Re: Water Quality Standards to Protect Aquatic Life in the Delaware River  
Docket ID No. EPA-HQ-OW-2023-0222

PWD appreciates the opportunity to provide comments on a May 2023 report entitled *Nitrogen Reduction Cost Estimation Study Addendum 2 Technical Memorandum* ("DO Addendum"). This technical memorandum was prepared by Kleinfelder Inc. under contract to DRBC as an addendum to a January 2021 *Nitrogen Reduction Cost Estimation Study* report. The DO Addendum evaluates additional capital and annualized cost estimates for seven selected wastewater treatment plants in the Delaware estuary to achieve effluent DO concentrations of 4, 5, or 6mg/L, assuming changes having been made to the wastewater plants to reduce effluent ammonia concentration as described in the 2021 *Nitrogen Reduction Cost Estimation Study* report.

On behalf of the Philadelphia Water Department, we submit the attached comments on the draft report, Nitrogen Reduction Cost Estimation Study Plant Specific Cost Estimates, which was prepared by the consulting firm Kleinfelder Inc. ("Kleinfelder"), on behalf of the Delaware River Basin Commission ("DRBC") (the "Draft Report").

The following comments are submitted by

**Figure 1.) Engineering News Record Construction Cost Index (ENRCCI) Comparison September 2019 vs April 2023.**

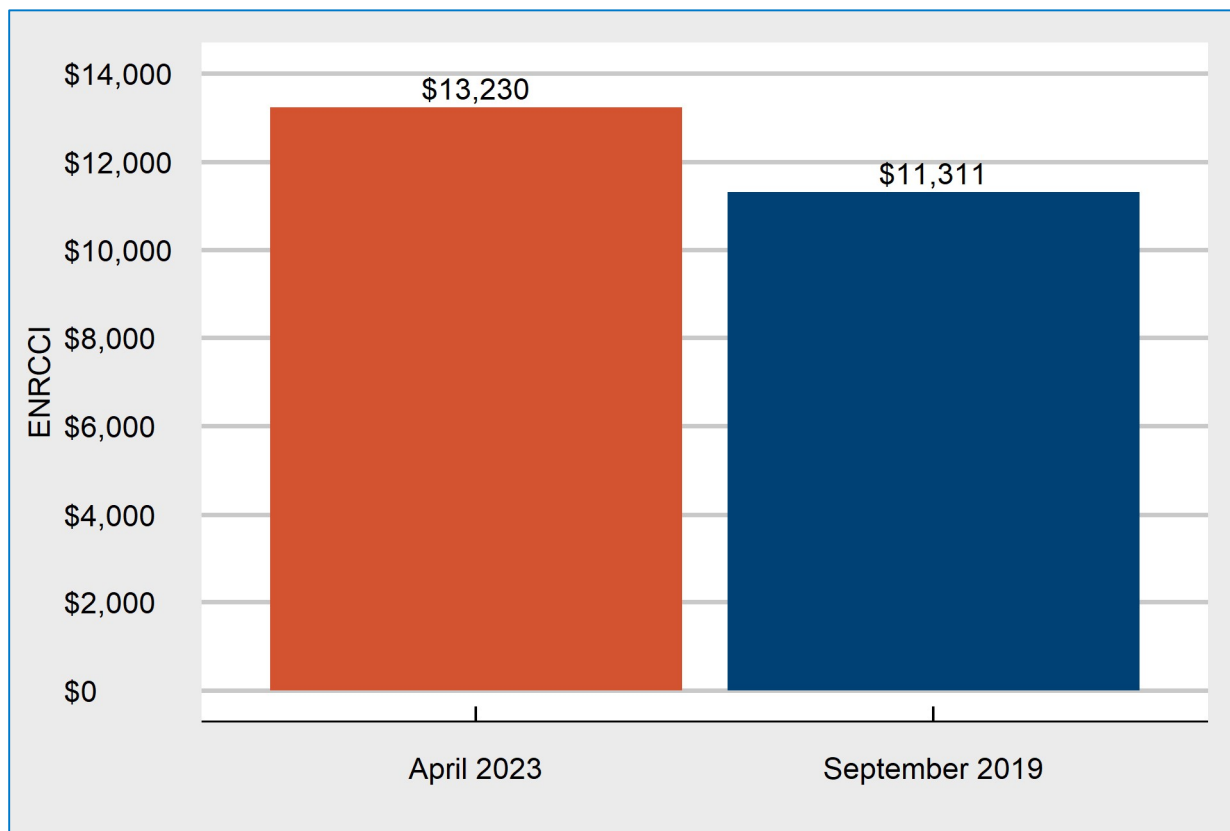
**1.) As described in detail in PWD’s 12/2/2022 comments on DRBC’s draft Analysis of Attainability, which are attached as Appendix A and incorporated herein by reference, PWD continues to have serious concerns regarding DRBC’s use of 2019 dollars for estimating capital and operating costs of proposed changes to wastewater treatment. PWD requests that DRBC and/or Kleinfelder update cost estimates for effluent ammonia removal and DO increases as soon as possible to be consistent with present-day (*i.e.*, 2023) costs.**

Page two of the DO Addendum states “For consistency, DRBC requested that the cost estimates be in 2019 dollars”. While PWD understands that DRBC has sought to avoid making multiple adjustments and re-calculations of costs while in the draft phases of evaluations performed for Resolution 2017-04, it is imperative that these costs be updated as soon as possible to enable a fair and transparent evaluation of costs going forward. A review of annual average Engineering News Record Construction Cost Index (ENRCCI) values demonstrates that updating cost estimates is not a minor “finishing touch” to be applied when finalizing the draft Analysis of Attainability, as the ENRCCI has increased **17%** since the September 2019 value used by DRBC and Kleinfelder for cost estimations (Figure 1; [ENR Construction Cost Index History](#)).

Figure 2.) Annual Average Engineering News Record Construction Cost Index 1960-2023. Red line segments indicate increases since 2019.

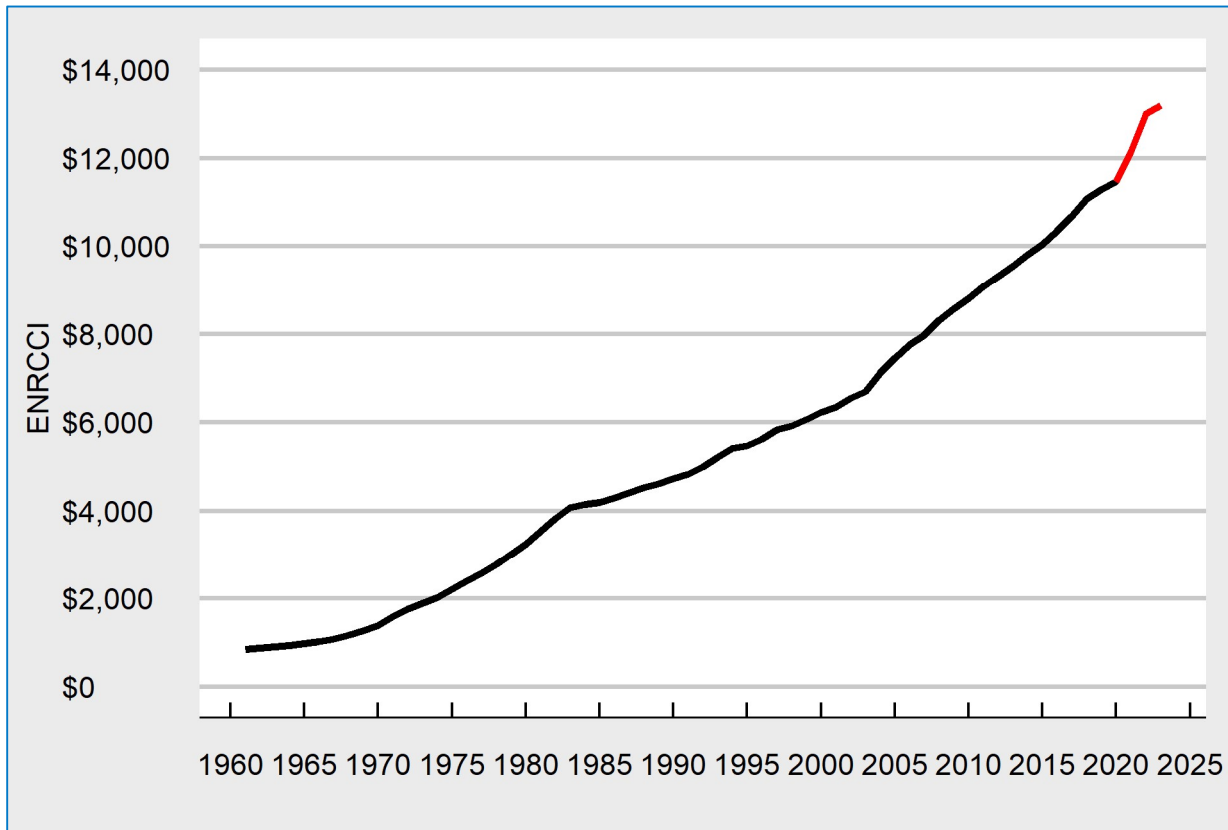
Driven by a global pandemic and major supply chain disruptions affecting many sectors of the US economy, the ENRCCI experienced an unprecedented increase of 8.4% from September 2020 to September 2021 and 5.7% from September 2021 to September 2022 (Figure 2; [ENR Construction Cost Index History](#)). As construction costs affect interpretations of the socio-economic and utility financial impacts of proposed changes to wastewater treatment, it is critically important for costs to be updated to reflect the very real and lasting effects of recent inflation on cost estimates.
